UNITED STATES PATENT AND TRADEMARK OFFICE

Office Action Summary	Application No. 10/598,406	Applicant(s) NORDLI, BJARNE	
	Examiner ANTHONY N. BARTOSIK	Art Unit 3635

This is a Non-Final Rejection sent in response to Applicant's RCE of 12/03/2009.

5. **Claims 2-14 are rejected under 35 U.S.C. 102(b) as being anticipated by Stein (U.S. 5,282,343).**

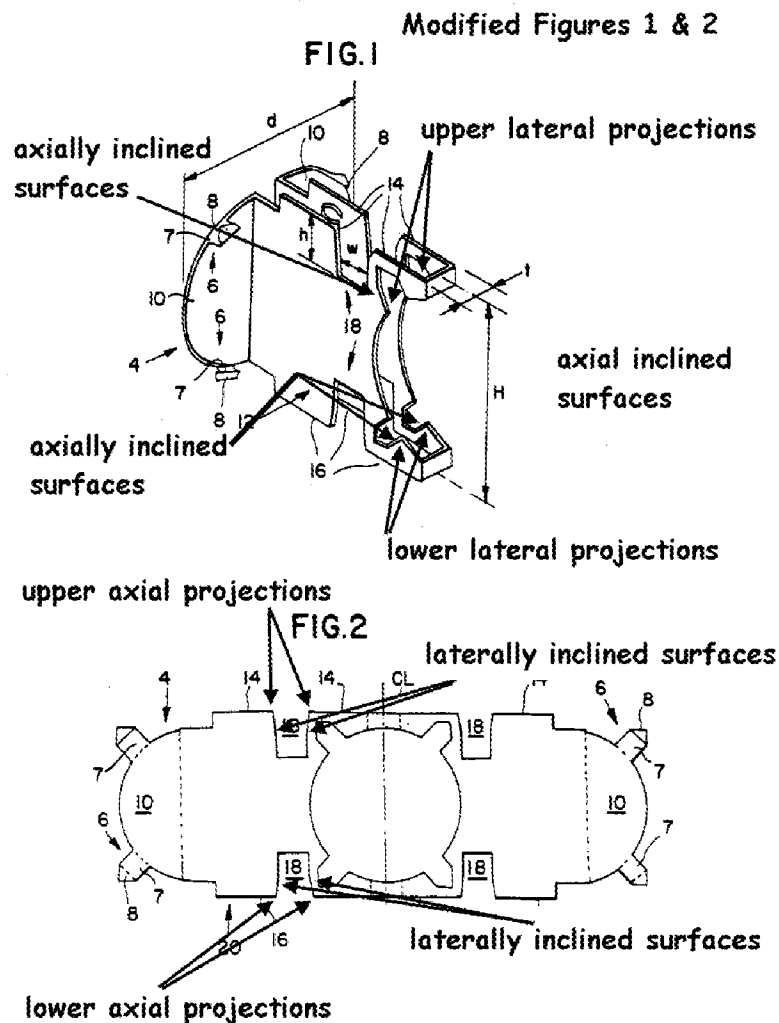
6. In Re claim 14, Figures 1-7 of Stein disclose in combination with two log constructional elements (corresponding members 24 from each wall 30 & 36 in Fig. 7) used in log wall construction, a cogging piece (2) with lateral and axial inclined surfaces (see Mod. Figs. 1-2 below). The additional language provided in claim 1 is either functional language or intended use language. To be limiting functional language or intended use language must result in a structural difference between the claimed invention and the prior art in order to patentably distinguish the claimed invention from the prior art. If the prior art structure is capable of performing the intended use it meets the limitations of the claim. MPEP 2106 (c) & 2114. Here, Stein is capable of meeting the functional and intended use limitations.

7. In Re claim 2, Figures 1 and 2 (see modified Figs. 1 & 2) of Stein disclose two upper axial projections with laterally inclined surfaces and two lower axial projections with laterally inclined surfaces, two upper lateral projections with axially inclined surfaces and two lower lateral projection with axially inclined surfaces.

8. In Re claims 6 and 7, Figures 1 and 2 (see modified Figs. 1 & 2) of Stein disclose the claimed symmetrical orientation of the upper and lower axial projections.

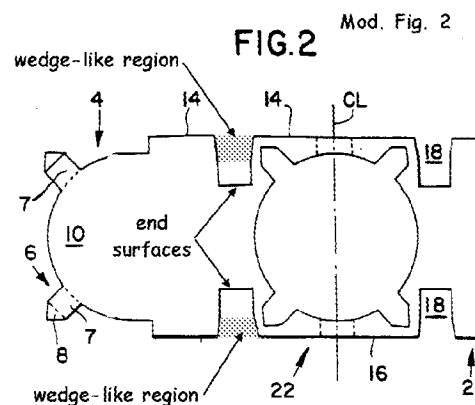
13. In Re claim 12, Figure 2 (see Mod. Fig. 2 below) of Stein discloses a substantially wedge-like region (shaded region) is defined between said upper laterally inclined surfaces, said region corresponding with the shape of said two lower lateral projections, and wherein two cogging pieces positioned adjacent to each other will have their end surfaces in contact with each other. The Examiner is interpreting the "corresponding with the shape" limitation to be met by the fact that the two elements are both shaped and located on the same piece, such an interpretation is reasonable as "corresponding" is not defined.

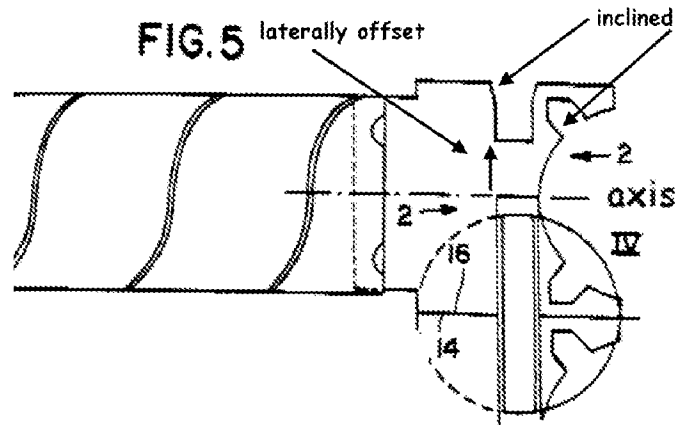
14. In Re claim 13, Figure 2 (see Mod. Fig. 2 above) of Stein discloses a substantially wedge-like region (shaded region) is defined between said lower laterally inclined surfaces, said region corresponding with the shape of said two upper lateral

projections, and wherein two cogging pieces positioned adjacent to each other will have their end surfaces in contact with each other. The Examiner is interpreting the "corresponding with the shape" limitation to be met by the fact that the two elements are both shaped and located on the same piece, such an interpretation is reasonable as "corresponding" is not defined.
